Policy Amendments to Bowness ARP

(a) In 7A. Greenbriar Area Land Use, delete Policy 8 and replace with the following:

c. Residential Interface

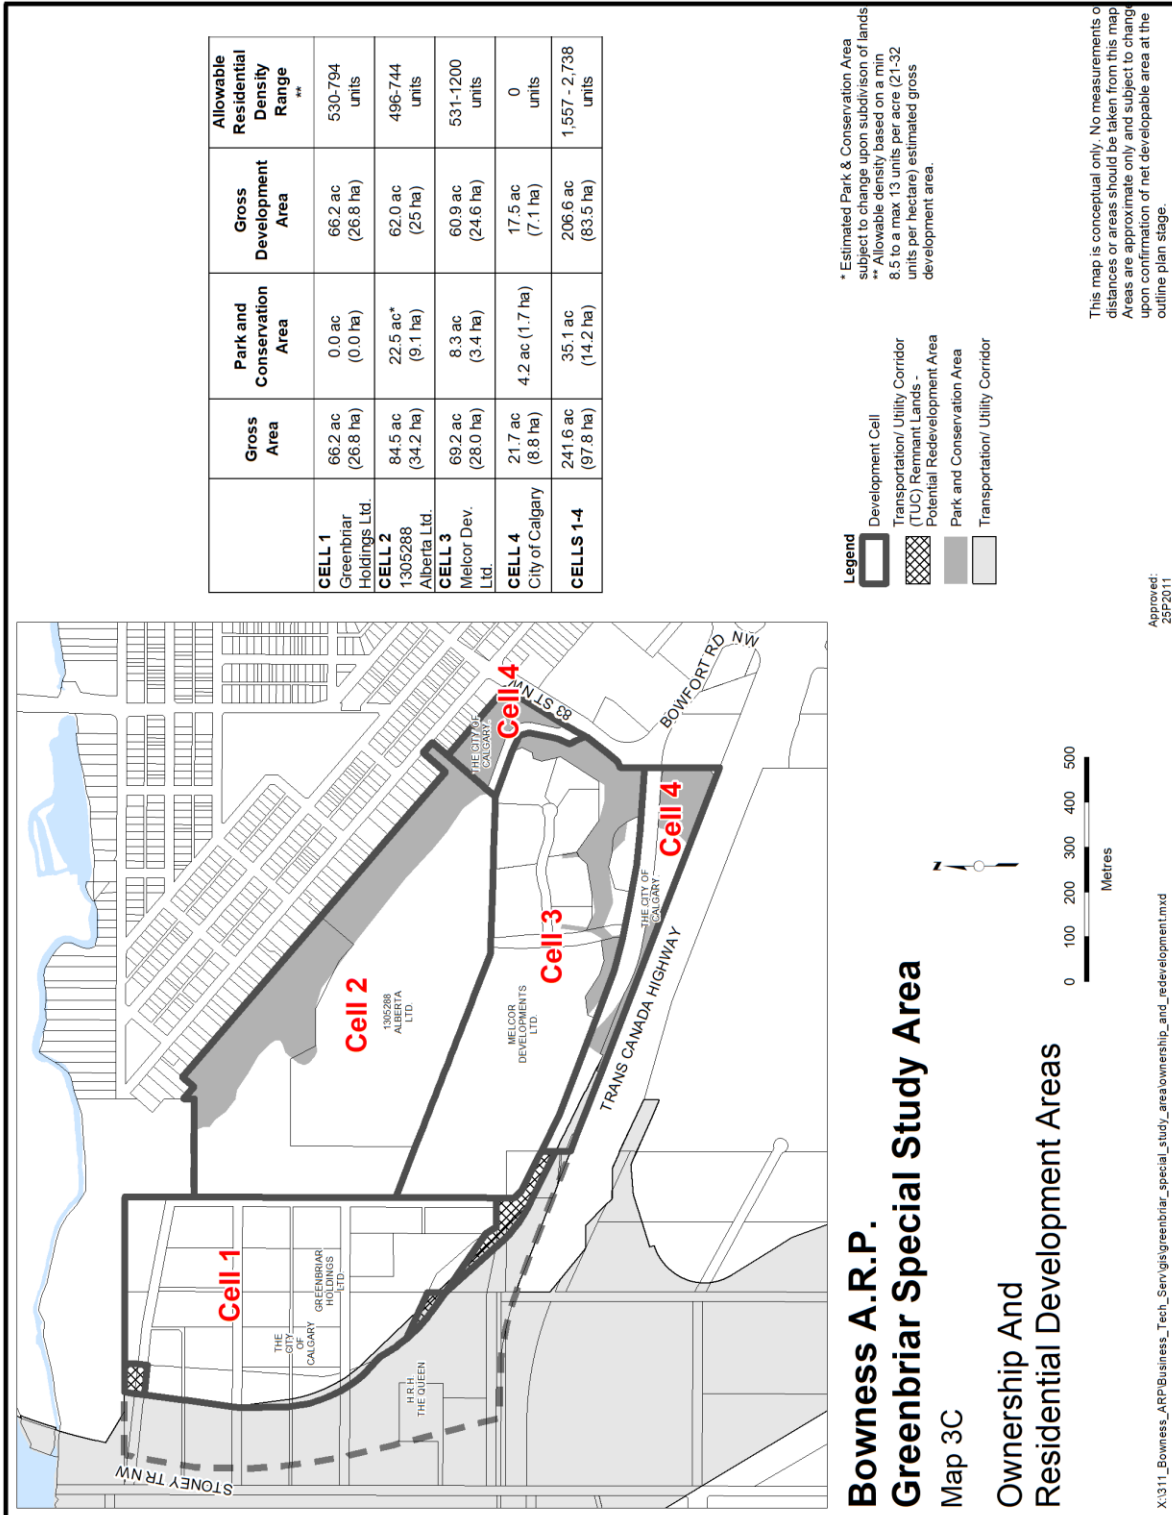
- Provide a sensitive transition between the Mixed Use Village and adjacent low-density residential developments by incorporating a gradual building height transition, street-oriented uses and a landscaped buffer.
- Provide maximum building height of 12 metres to minimize shadow and massing impacts to the north.”
